Access Compliance Report

Public Rights-of-Way

(Curb Ramps)

Intersection ID: N/A	Main Street: FREEDOM_DR	Cross Street: N_I-85_RA	Location: N
ADA ID: DB1E64E8C722	Ramp Type: Directional1	Initial Pass/Fail: Pass	Overall Compliance: No
Severity Score: 15.25			
Codes/Mitigation Info/Possible Solution		Field Measurements/Component Compliance

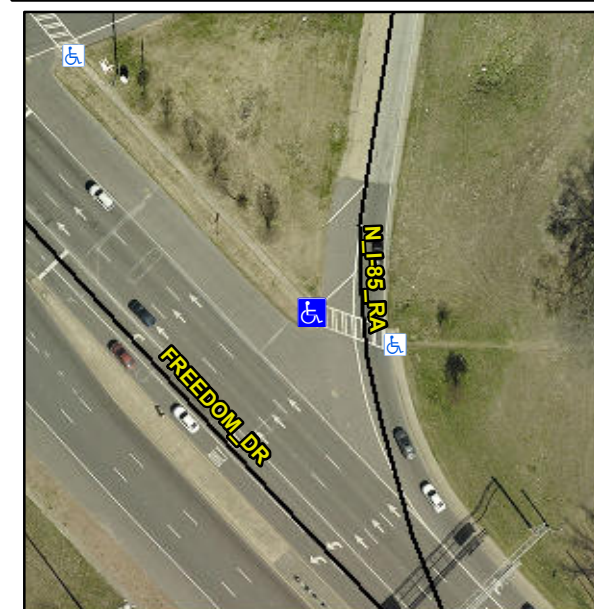
PROW/ADA:

R304.5.3, R305.2, R302.7.2

Compliance	Description	Data	Compliance	Description	Data
N/A	Ramp Length (in)	71.0	Yes	Grade Break?	Yes
Yes	Ramp Width (in)	60.0	Yes	Grade Break Slope (%)	0.8
Yes	Ramp Slope (%)	1.4	No	Grade Break XSlope (%)	3.1
No	Ramp XSlope (%)	3.2			
N/A	Flare Type LT	N/A	N/A	Flare Type RT	N/A
N/A	Flare Slope LT (%)	N/A	N/A	Flare Slope RT (%)	N/A
N/A	Flare Traversable LT?	N/A	N/A	Flare Traversable RT?	N/A
Yes	Landing Length (in)	61.0	Yes	DWS Provided?	Yes
Yes	Landing Width (in)	60.0	Yes	DWS Contrast?	Yes
Yes	Landing Slope (%)	1.8	Yes	DWS Length (in)	24.0
No	Landing X Slope (%)	3.5	Yes	DWS Full Width?	Yes
N/A	Landing Curb? (Y/N)	N/A	Yes	DWS Offset LT (in)	48.0
N/A	Shared Landing?	No	No	DWS Offset RT (in)	5.0
Yes	Gutter Ponding?	No	Yes	Gutter Slope (%)	2.3
No	Gutter Lip Ht (in)	1.0	Yes	Gutter X Slope (%)	1.4
N/A	Painted X Walk1?	Yes		Road Slope (%)	1.7
	X Walk 1 Direction	To SE		Road X Slope (%)	2.3
	X Walk 1 Width (in)	116.0		Clear Space?	Yes

X Walk 1 Slope (%)	1.7	N/A	Clear Space to XWalk (in)	N/A
	X Walk 1 X Slope (%)	2.3	Yes	Storm Grate/Utility Hazard?	No
Yes	Ramp inside XWalk1?	Yes		Storm Grate/Utility Type	
Yes	Any Obstructions?	No			N/A
	Obstruction Type		Yes	Surface Condition? (G/P)	Good
			N/A	Curb Slope (%)	4.5

**Remove & Replace Entire Ramp.
Grind Gutter Lip.**
